△1 ADDENDUM 1: DATE: 10-16-07

MD 355 (ROCKVILLE PIKE) AND MD 187 (OLD GEORGETOWN ROAD)

TRAFFIC SIGNAL PLAN

TS NO. 3262C | DRAWING NO. 1 OF 3 | SHEET NO. 31 OF 42

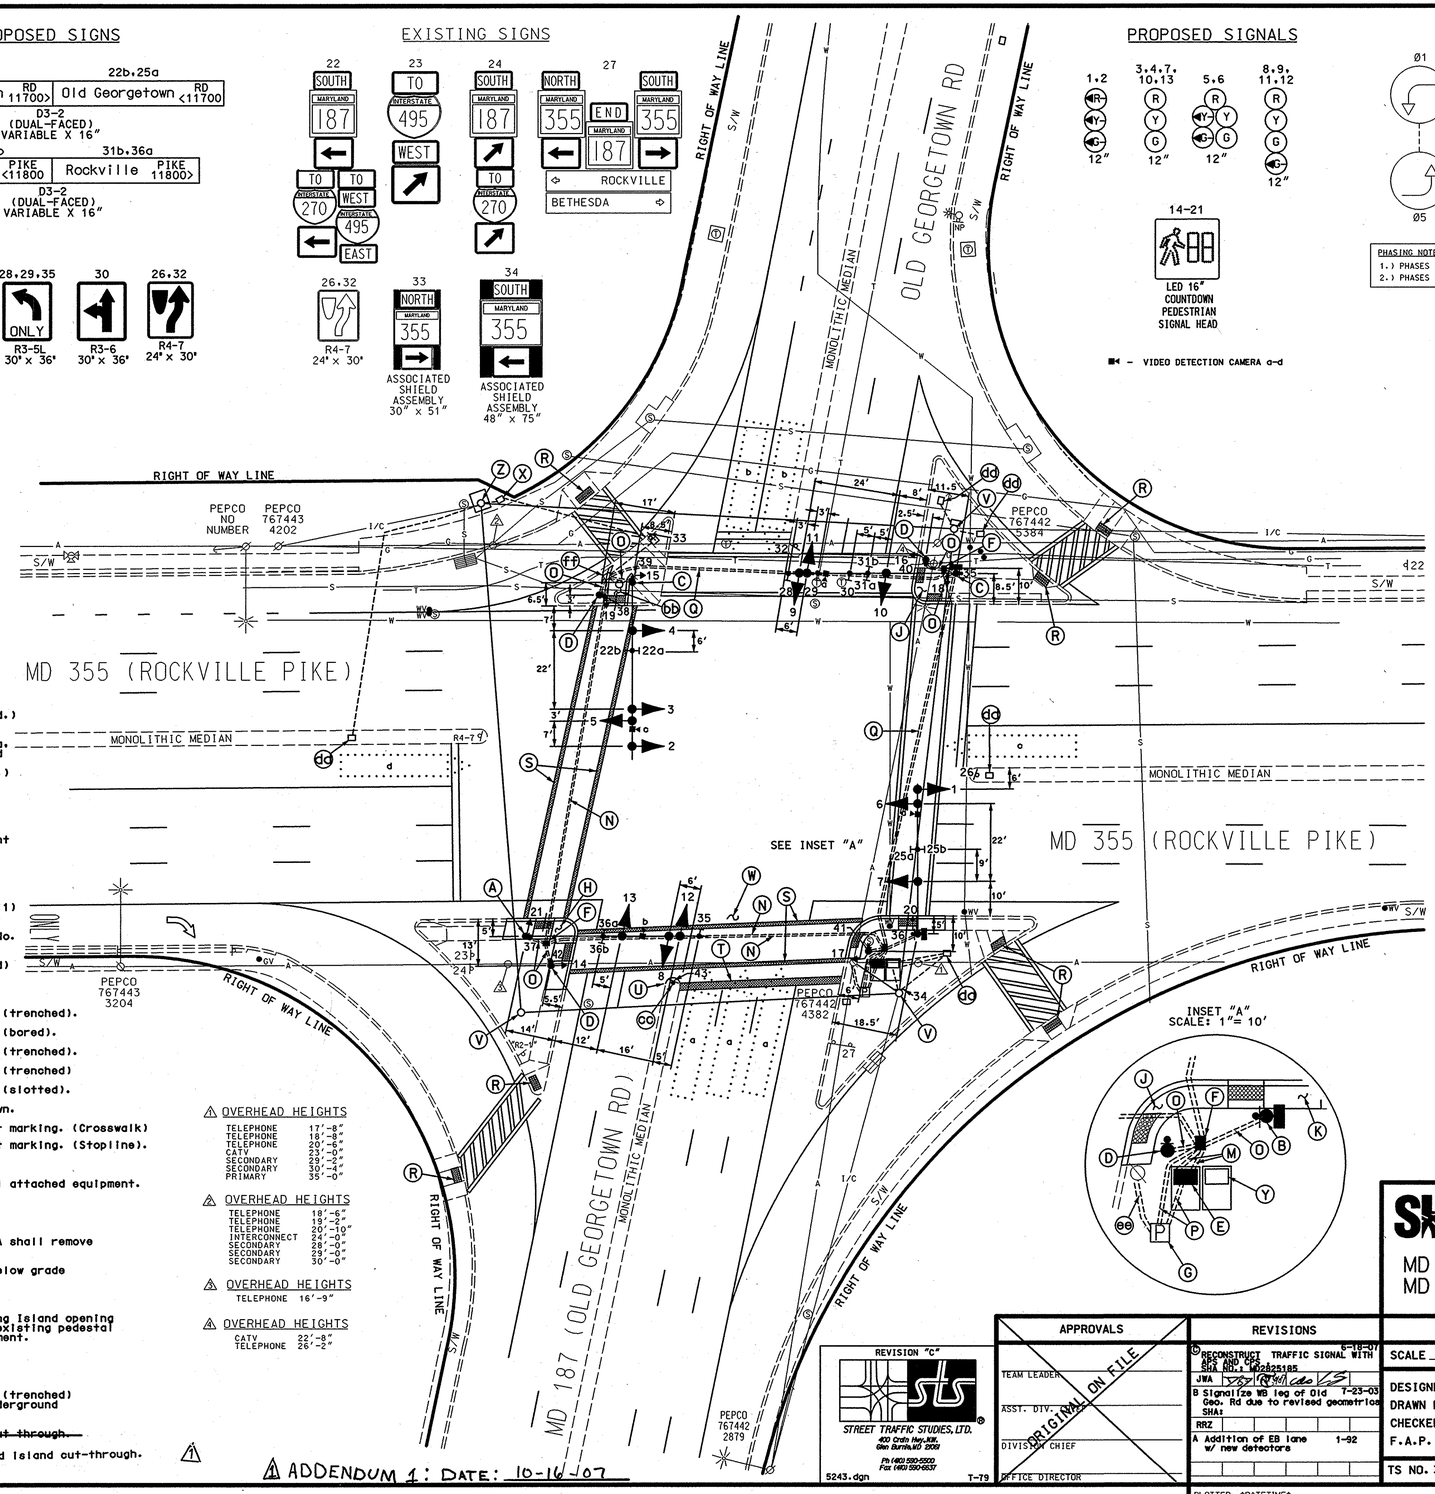
L. Install ~~4"~~ 5" concrete sidewalk as shown. △1

Q. Install ~~4"~~ polyvinyl chloride electrical conduit (Schedule 80) (slotted).

ee. Install 3" polyvinyl chloride electrical conduit (Schedule 80) (trenched) with 50' of ~~3 wire~~ 1 conductor (No. 250 KCMIL) for proposed underground electrical power service by PEPCO to base of utility pole.

ff. Contractor shall adjust existing handhole lid to grade to avoid island cut-through. △1

△1 OVERHEAD HEIGHTS

TELEPHONE	17'-8"
TELEPHONE	18'-8"
TELEPHONE	20'-6"
CATV	23'-0"
SECONDARY	28'-2"
SECONDARY	30'-4"
PRIMARY	35'-0"
